Amendment no . 1 dtd 25.03.11 - SCADA/DMS Model technical specification (MTS) under R-APDRP

**FIG. 4-2 : CONCEPTUAL CONFIGURATION OF DC POWER SUPPLY (DCPS) SYSTEM**

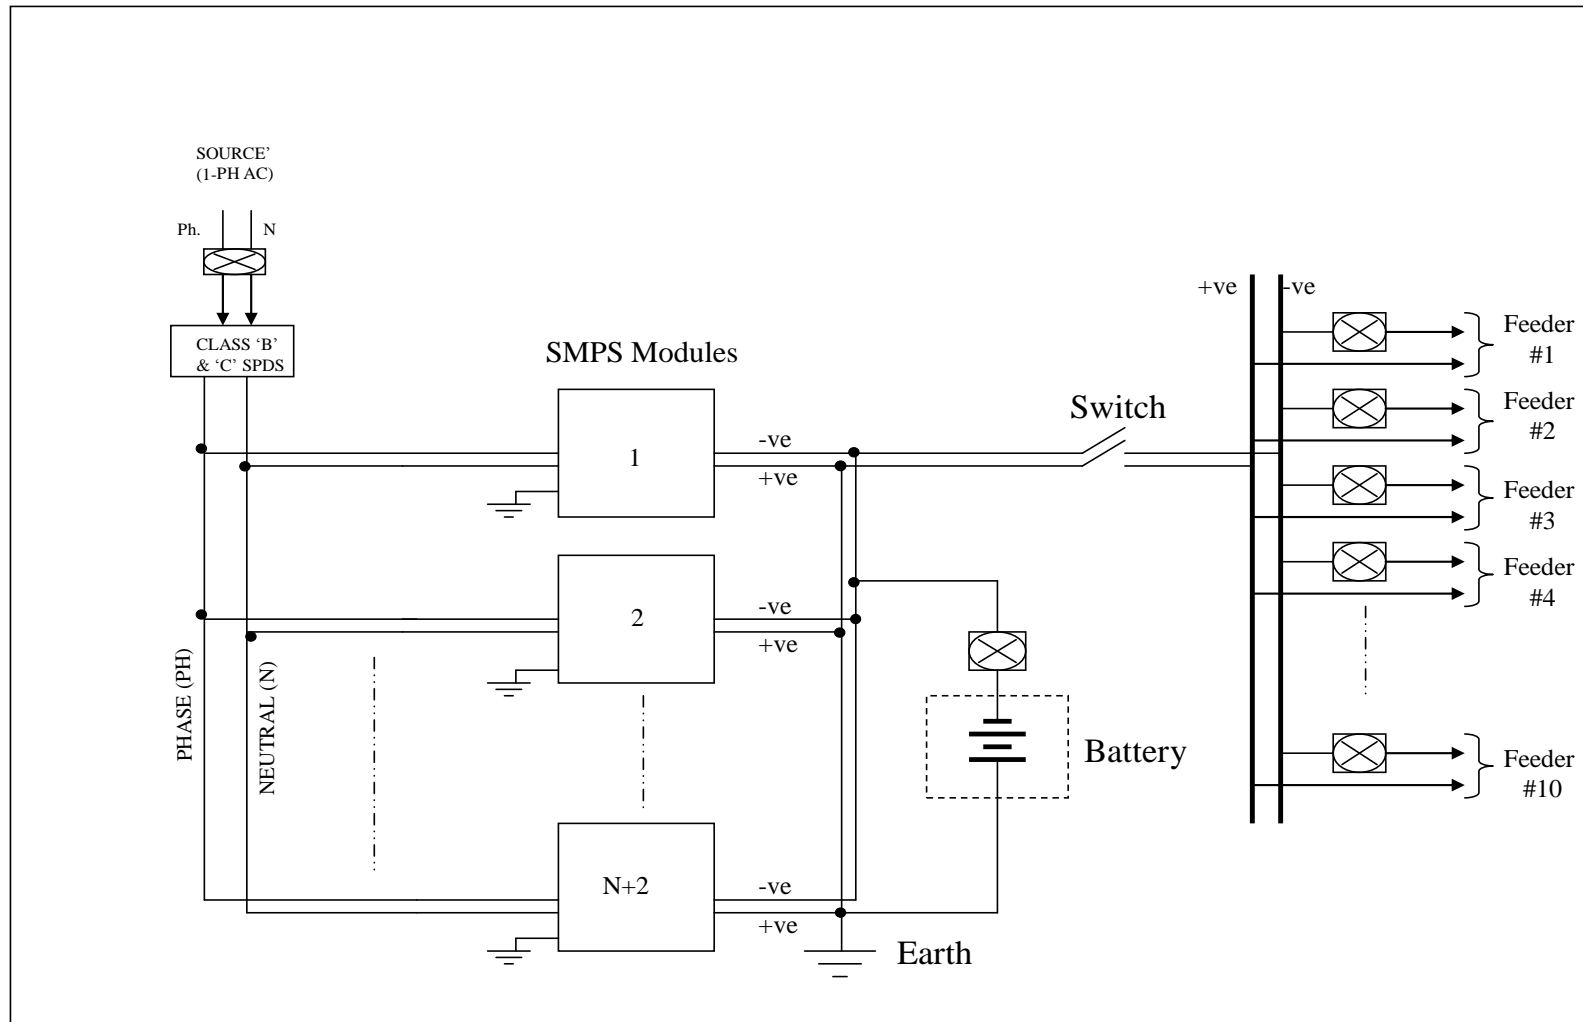
Annex1
